NEW ELEMENTARY SCHOOL

REED SITE, ARLINGTON PUBLIC SCHOOLS

CONCEPT DESIGN

BLPC + PFRC JOINT MEETING

COMMENTS – INTEGRATED

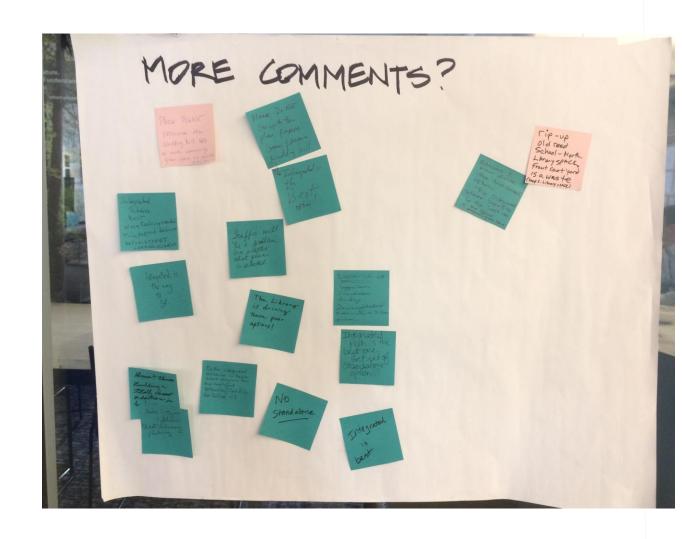
- Best option by far
- Great solution for students
- Good idea to preserve park
- Does not maximize seats for Arlington
- This scheme has a good community feel\
- Like the option of building up
- Would be good with a parking garage behind it
- Please consider underground parking option
- 3 story height a concern
- This is the only acceptable option
- Maintains sledding hill
- Smaller footprint best for students

COMMENTS - PARKING

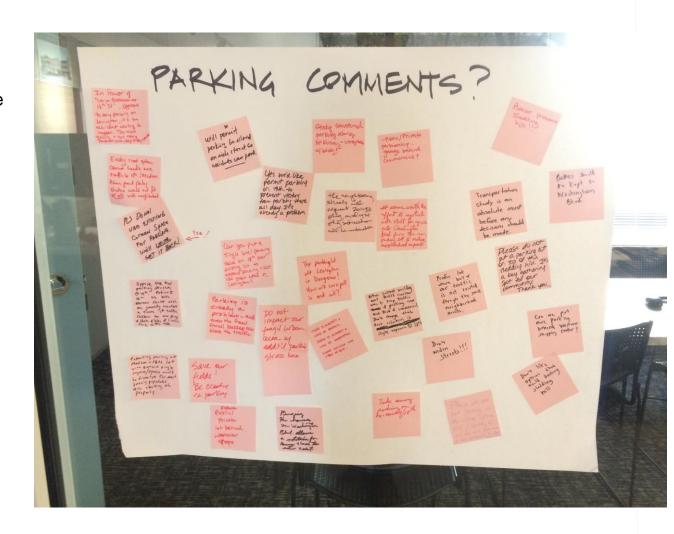
- In favor of larger expansion on 18th St: opposed to parking on Lexington due to safety
- Existing road system can't handle traffic @ 18th and Madison: above ground parking wouldn't fit in neighborhood

- Don't use existing green space for parking: we'll never get it back
- Study structured parking along McKinley
- Opposed to parking structure at 18th and Madison: both narrow streets

- Explore public/private lot behind Westover Shops
- Take away parking on McKinley & 18th
- Can you put a parking lot on 18th over existing lot
- We'd like to permit parking on 19th to prevent visitors from parking there: it's already a problem

- Permit parking on side street so residents can park
- Do not impact our fragile urban area with additional parking stress
- Don't like options that would destroy sledding hill and/or upper field

- Preference given to options that do not route traffic through smaller neighborhood streets
- Transportation study is absolute must prior to any decisions
